**Z-60  
(2013)**

CONCEPTUAL ZONING PLAN FOR  
**BROOKS CHADWICK CAPITAL**  
 BEING TRACT 1 & TRACT 2 OF THE ROBERT E. DENVERBY ESTATE  
 PROPERTY IS LOCATED IN LAND LOT 538  
 IN THE 18TH DISTRICT 2ND SECTION, COBB COUNTY, GEORGIA

### **Z-60 BROOKS CHADWICK CAPITAL, LLC**

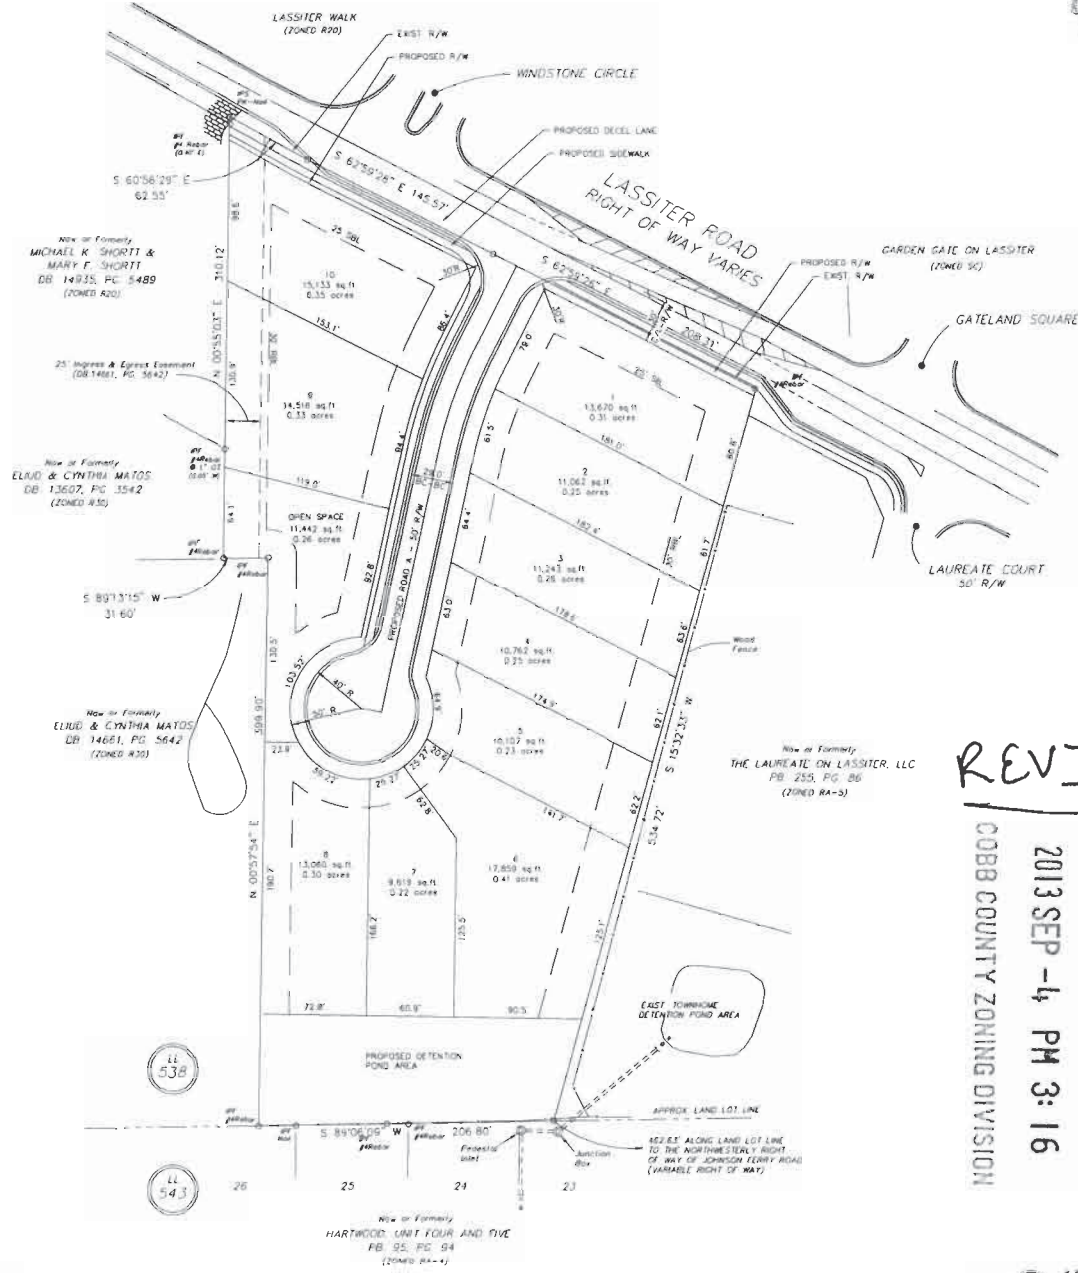
**Staff estimate for allowable # of units:** 4      **Units\***      **Increase of:** 6      **Units/Lots**

1. Waive the front setback from 40 feet to 20 feet;
2. Waive the rear setback for exterior lots from the required 40 feet to 30 feet; and
3. Waive the major side setback along Lassiter Road from 35 feet to 25 feet.

- No Stormwater controls shown \_\_\_\_\_
- Copy of survey is not current – Additional comments may be forthcoming when current site conditions are exposed.
- No site improvements showing on exhibit.

2. Subject to approval by the Heartwood Subdivision HOA, the applicant has agreed to Stormwater Management Division’s recommendation that the proposed detention pond discharge be tied directly into the existing private stormdrainage system located near the southeast corner of the site. This would eliminate overland flow runoff issues that currently exist within Heartwood Subdivision. It is further recommended that when the connection is made that the weir inlet of the existing junction box be lowered to reduce bypass currently occurring at this inlet.

Recommend applicant consider entering into a development agreement pursuant of O.C.G.A. 36-71-13 for dedication of the following system improvements to mitigate traffic concerns: a) donation of right-of-way on the south side of Lassiter Road, a minimum of 30' from the roadway centerline.

Recommend a deceleration lane on Lassiter Road for the entrance.

Recommend development street either directly align or have an offset of a minimum of 125 feet from Windstone Circle per Development Standard 401.10.

Based on the above analysis, Staff recommends DELETING the request to R-15 subject to the following conditions:

- Site plan to be meet R-15 criteria;
- Fire Department comments and recommendations;
- Water and Sewer Division comments and recommendations;
- Stormwater Management Division comments and recommendations;
- Department of Transportation comments and recommendations; and
- Owner/developer to enter into a Development Agreement pursuant to O.C.G.A. §36-71-13 for dedication of system improvements to mitigate traffic concerns.
